Memorandum

Subject: **SITE PLAN REVIEW**—1900 N Croatan Highway in the Commercial Zone — Proposed Convenience Store and Gas Station

**RE: *2nd Site Plan Submittal for Wawa Croatan Highway
1900 North Croatan Highway
Kimley-Horn #116543032***

**WEST FOURTH
STREET PROFILES**

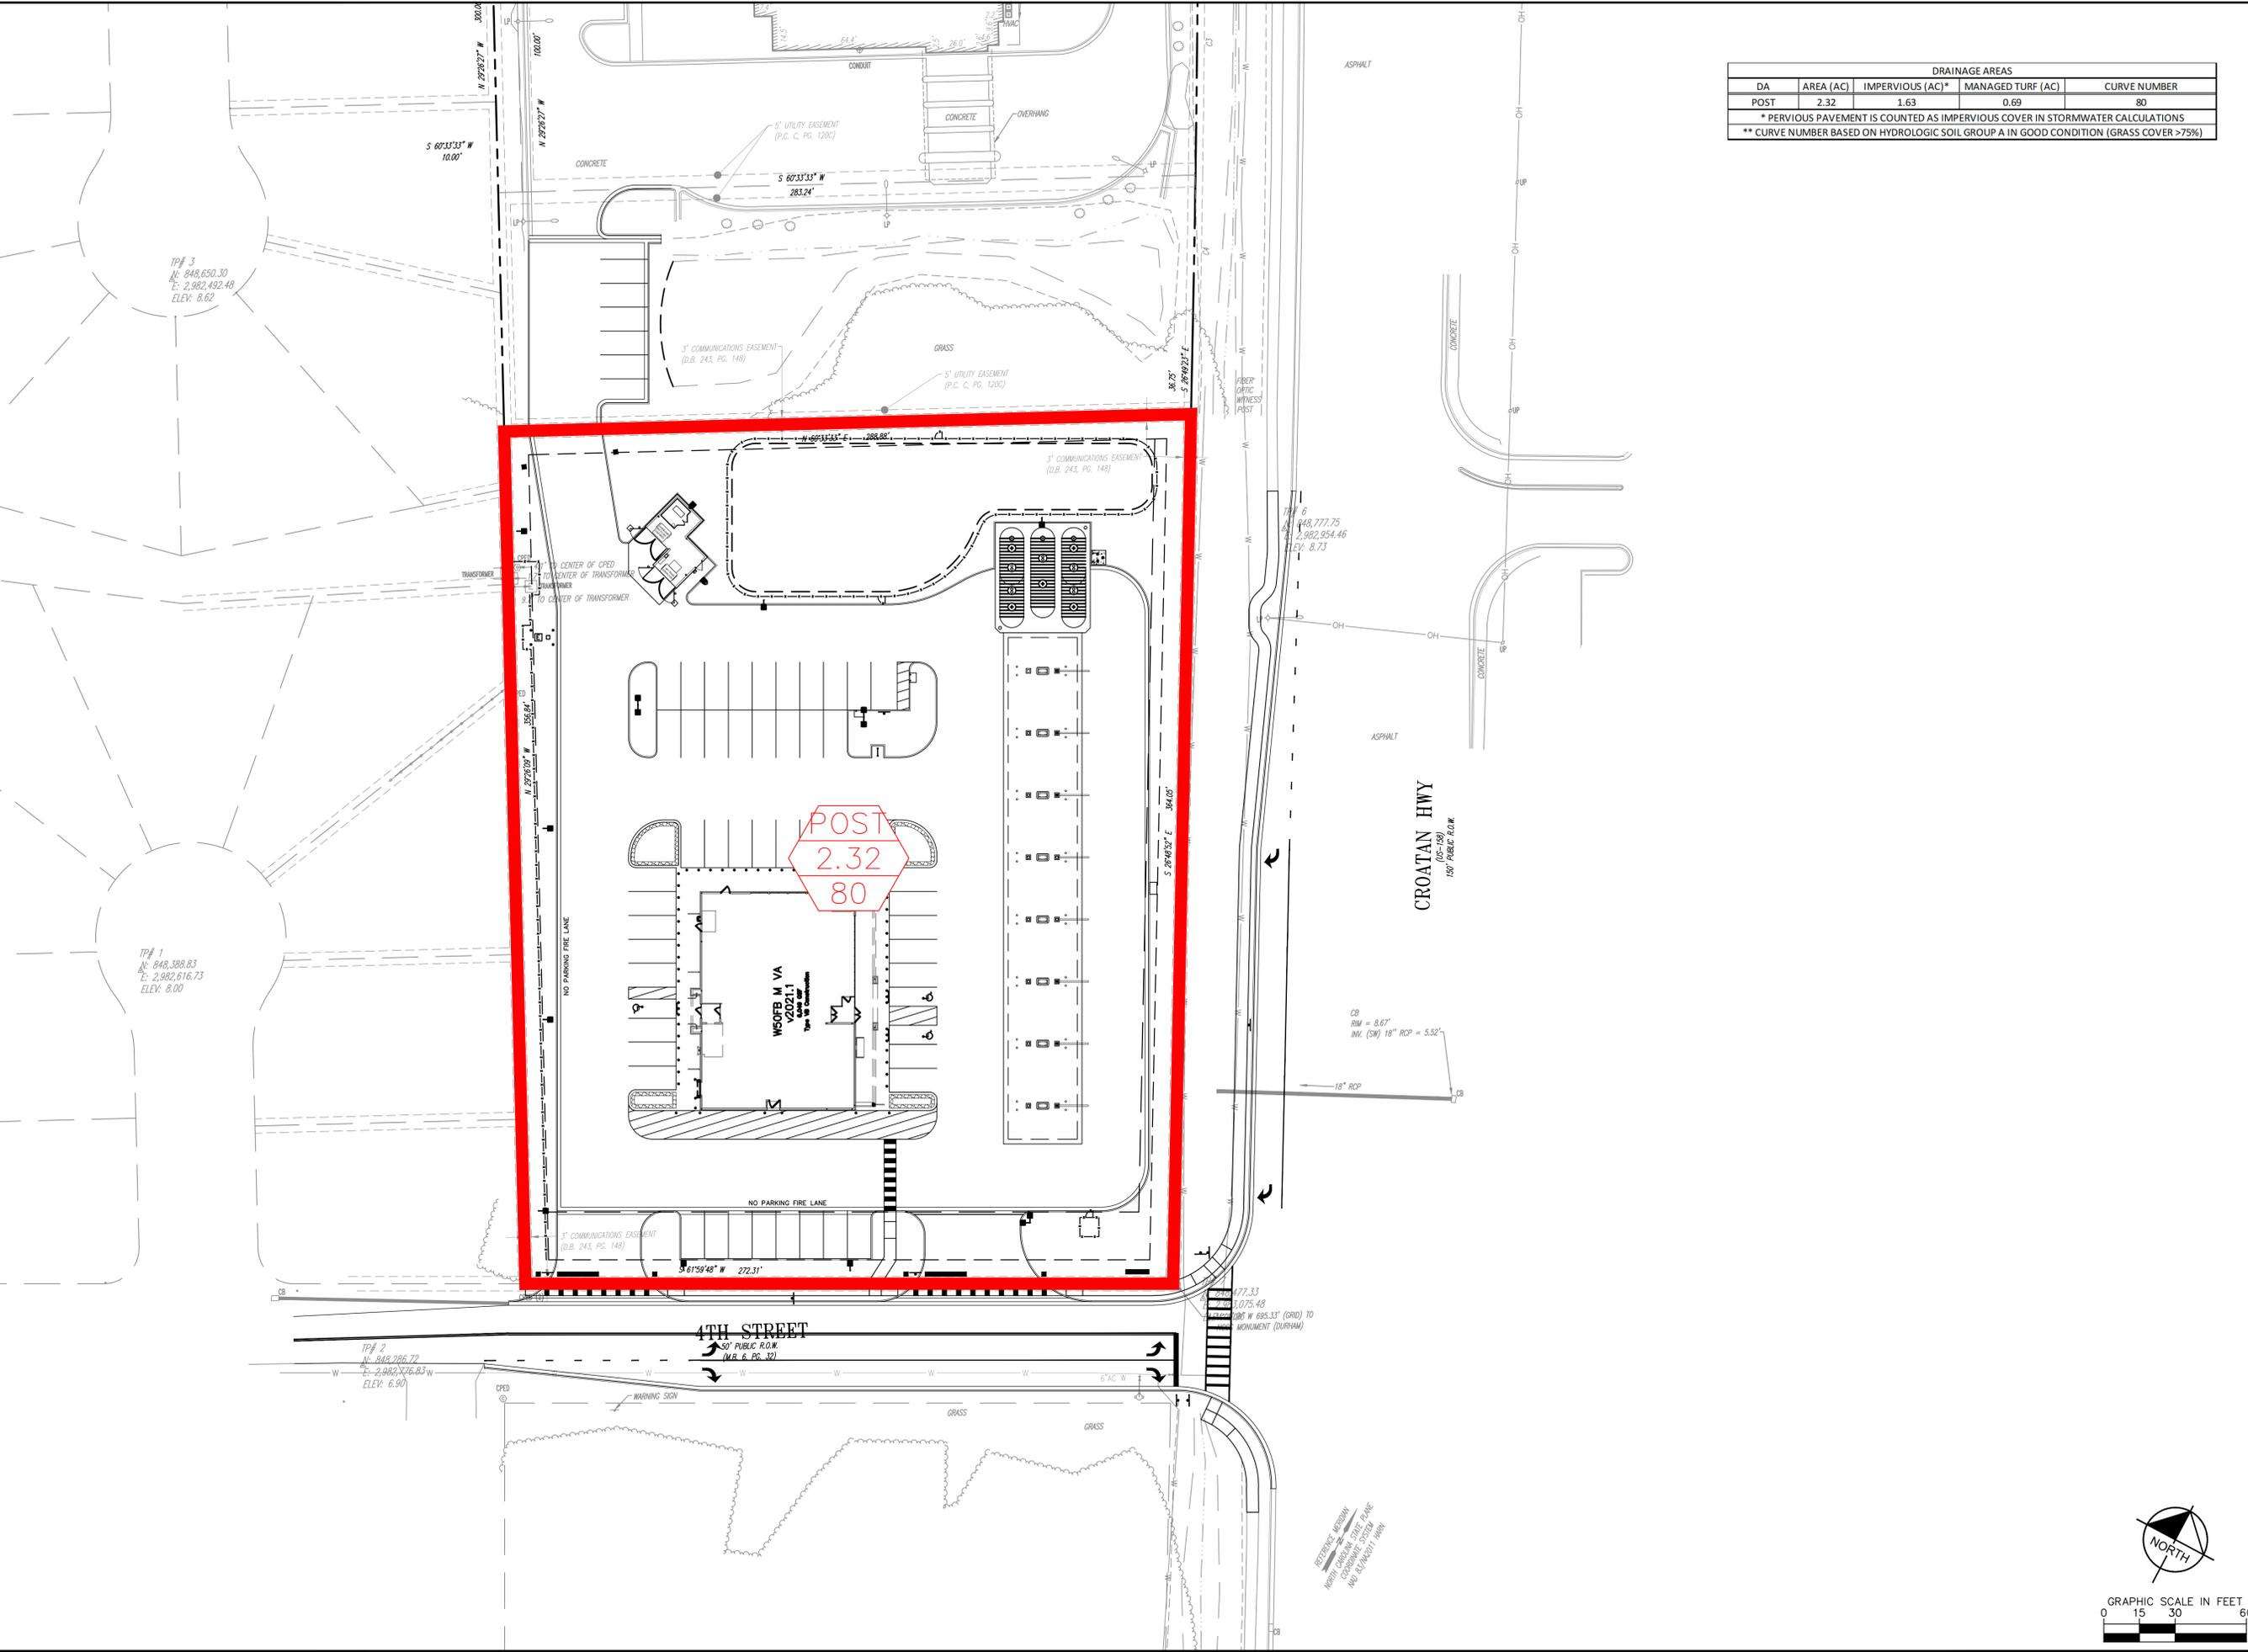
3. Provide required pavement overlay thickness in inches for the existing West Forth Street pavement section detail on Sheet CS506.
4. The proposed surface elevation at PVI station 11+95.81 on the West Fourth Street Profile on sheet CG103 appears to equal to the existing surface elevation. Please confirm that the pavement overlay thickness is accounted for in the profile and cross-sections.

- a. Provide plan and profile section of West Fourth Street in the proposed street improvement area. The existing street area at the east entrance is low and needs to be analyzed to see if the street's vertical alignment needs to be adjusted up to improve the intersection approach and access to the site.

- Plan and profile views of the proposed West Fourth Street alignment are included on sheet CG103. West Fourth Street will be raised to better match the existing elevation of Croatan Highway.

SHEET NUMBER
CU101

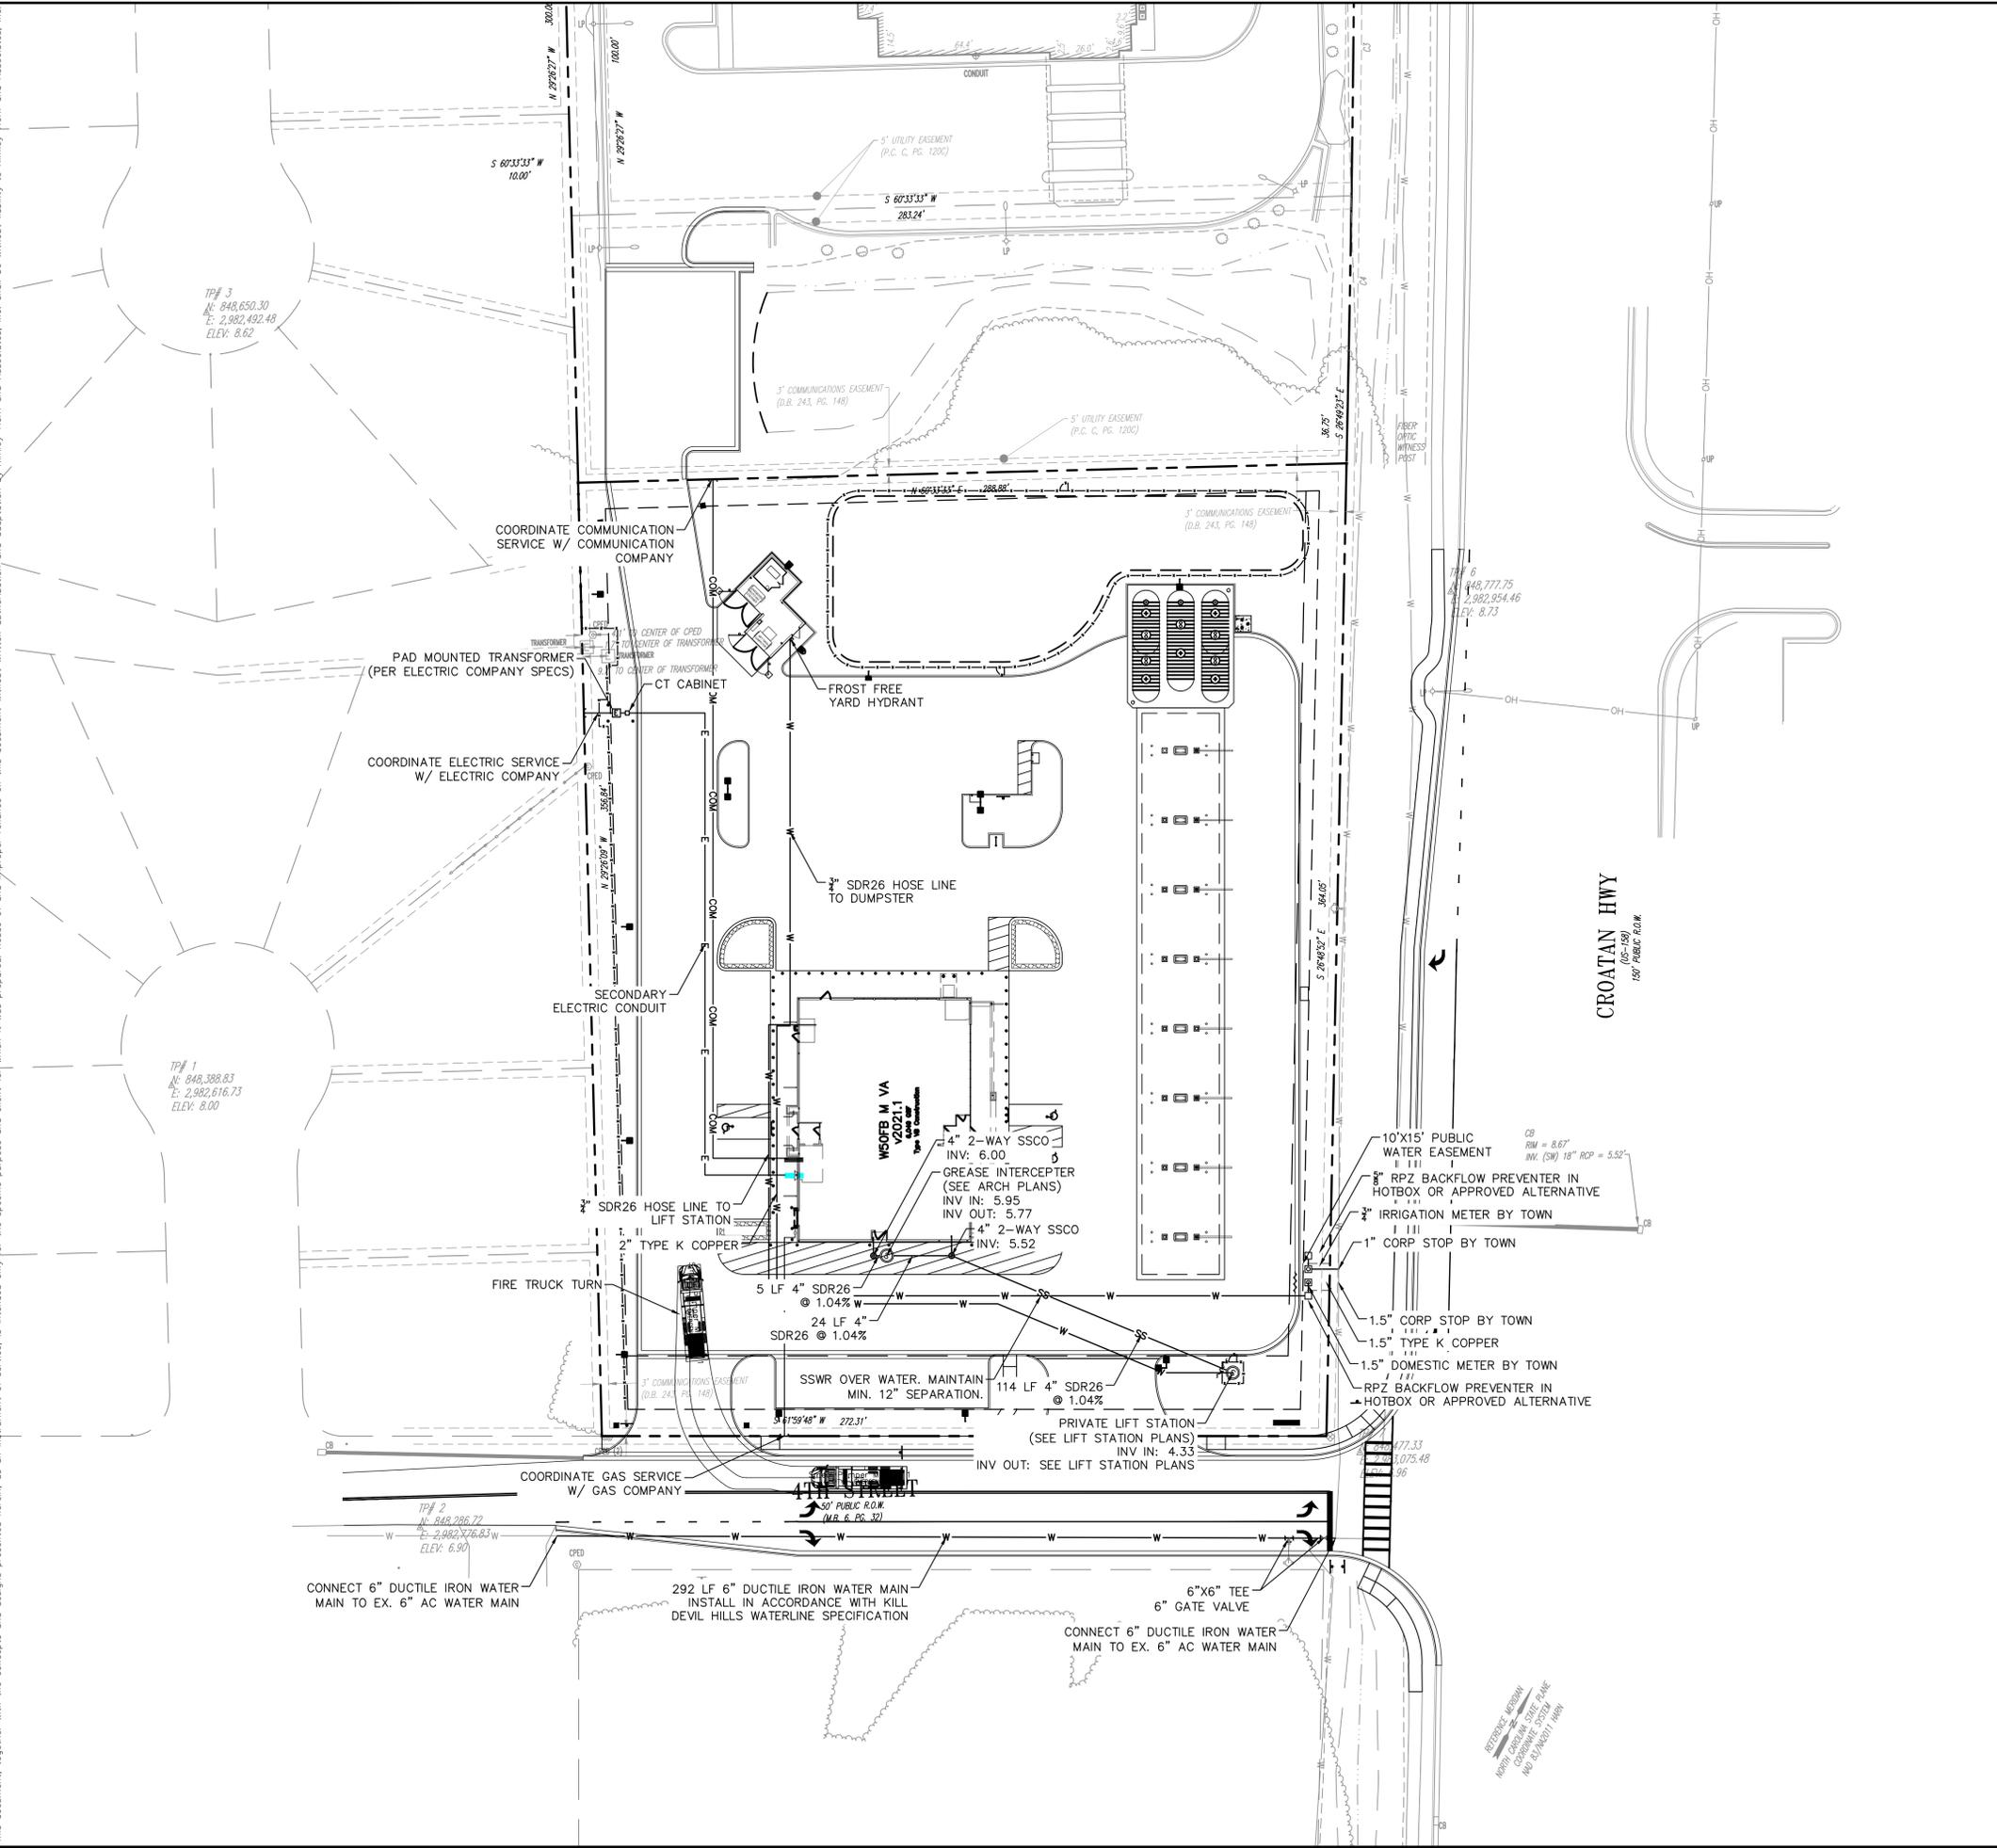
2. Add to the utility notes on Sheet CU101 that water main improvements are to be installed in accordance with the Town of Kill Devil Hills Standard Waterline Specifications.

6. Please confirm the response item 9.g in the Kimley Horn 4/5/22 comment response letter that *"Ten feet of horizontal separation is provided between the proposed water lines and sanitary sewer line."*

- An external RPZ is proposed downstream of the domestic water meter (CU101).
- g. On sheet CU101, the proposed water service is shown approximately 5 feet from the proposed sanitary sewer. Water service location shown should be at least 10 horizontally from the sewer service.

ADA PARKING SIGN DETAIL
N.T.S.

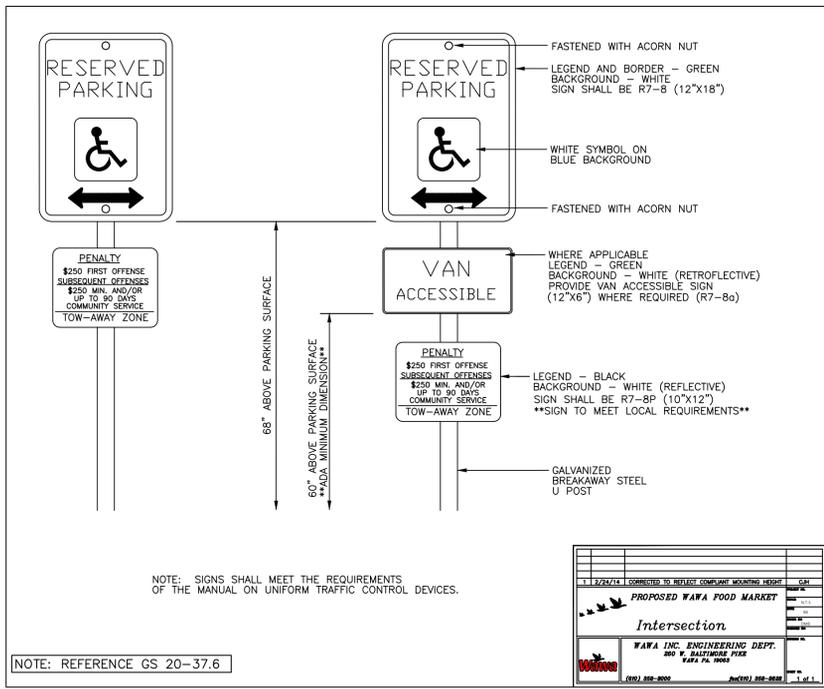
- i. (CS501): Handicap Parking Signage shall have reference to "GS 20-37.6"
 - A note was added to the parking signage detail which references "GS 20-37.6" (CS501).
